This gallery shows some pictures of bad solderings - they should prevent you from making the same errors (feel free to add even more pictures here!)

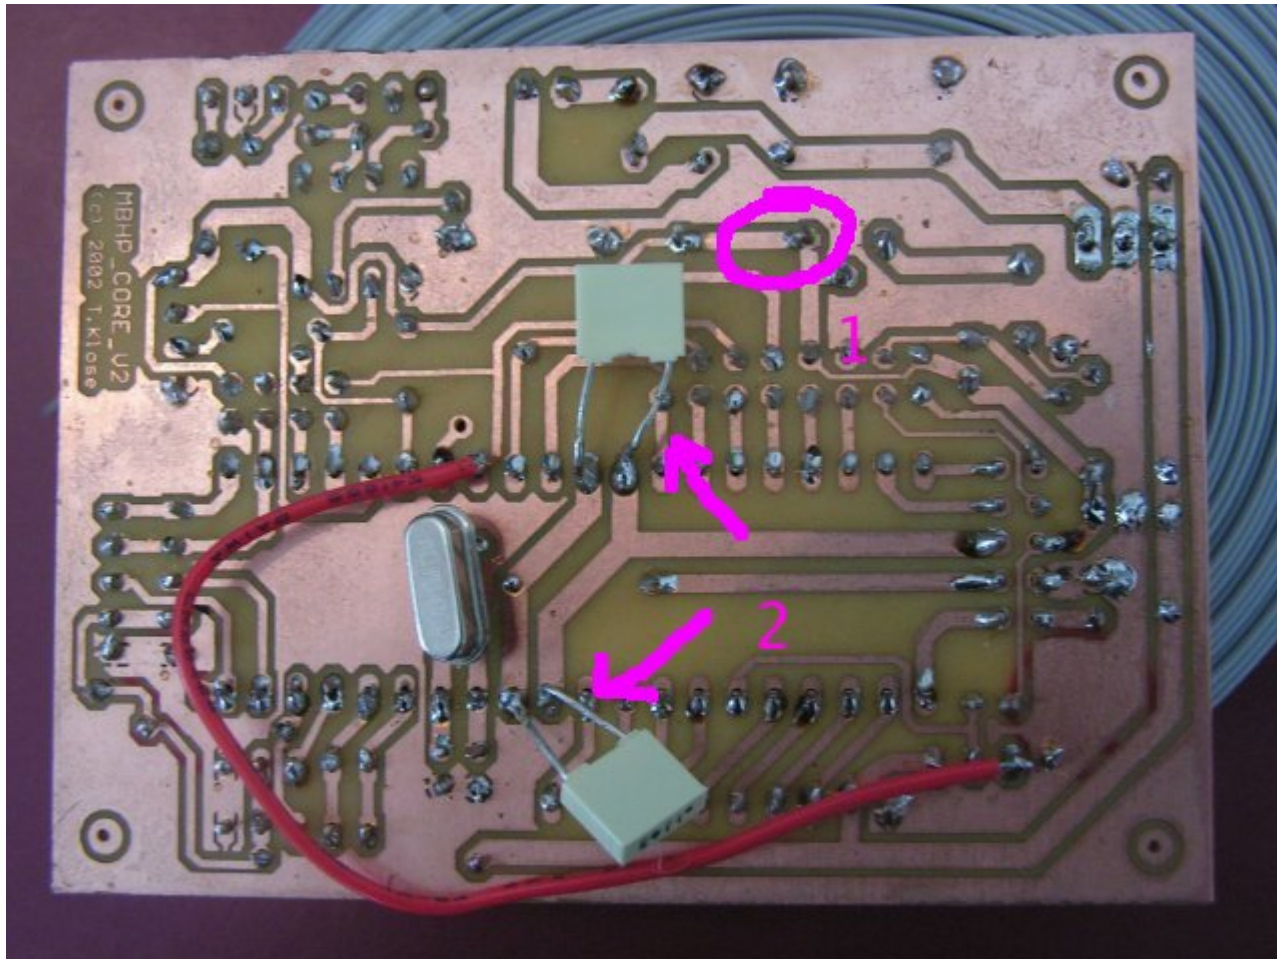
1: the core module has some bad solderings (loose connections), which could lead to failures. There are also missing solderings (e.g. 33pF cap below crystal). It makes sense to solder each pad again, the [Soldering](#) guide in the Wiki gives some useful tips

2: the legs of the caps should be cutted, otherwise they can cause a short circuit which can damage the PIC!

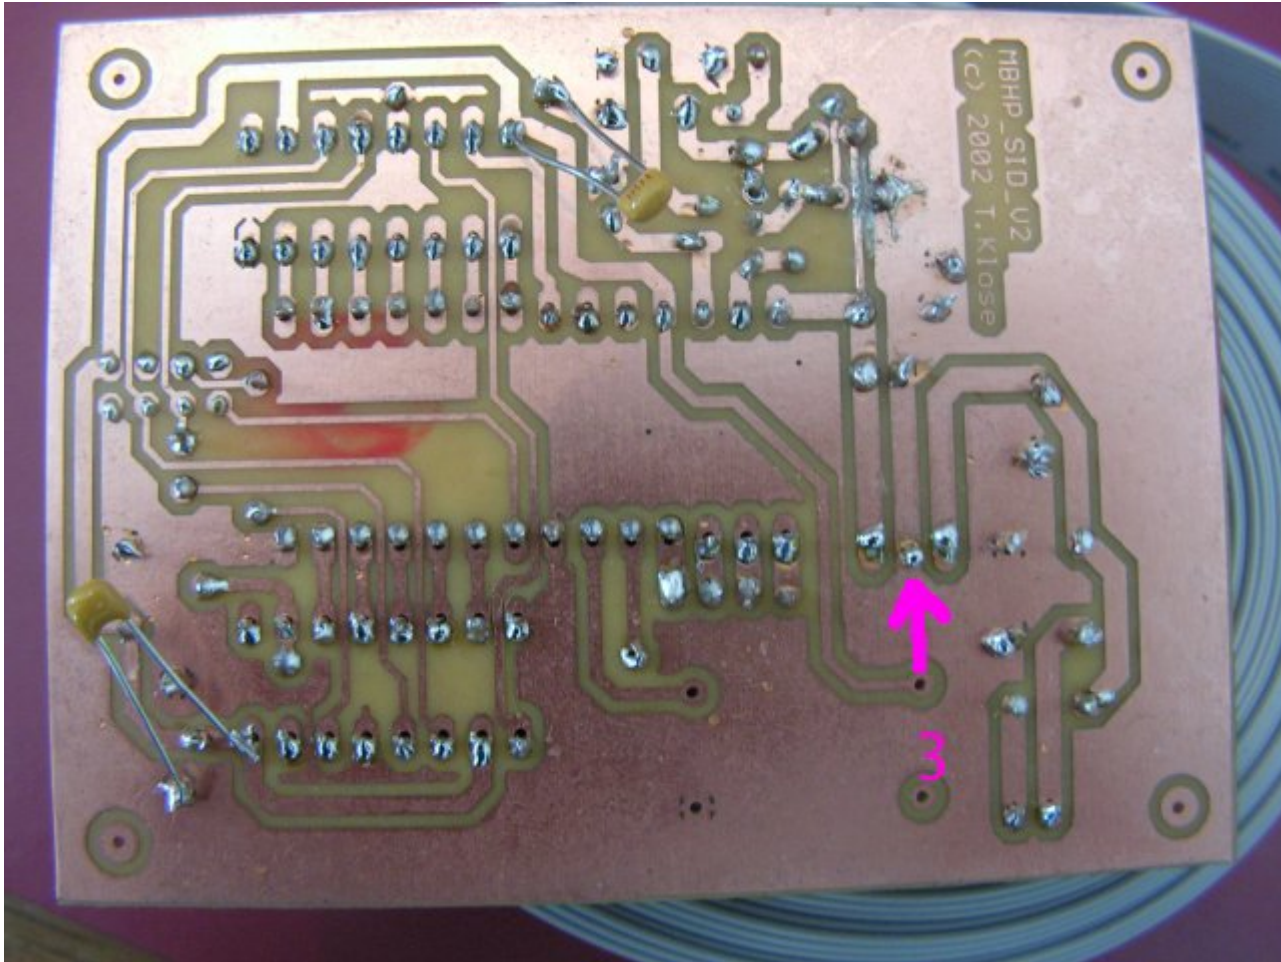
3: this seems to be a bad ground connection directly at the 78xx - it can lead to the wrong voltage. Here the same: just solder the pads again, it will help
And same like above: the long cap legs need to be cutted, the danger for shorts is too high!
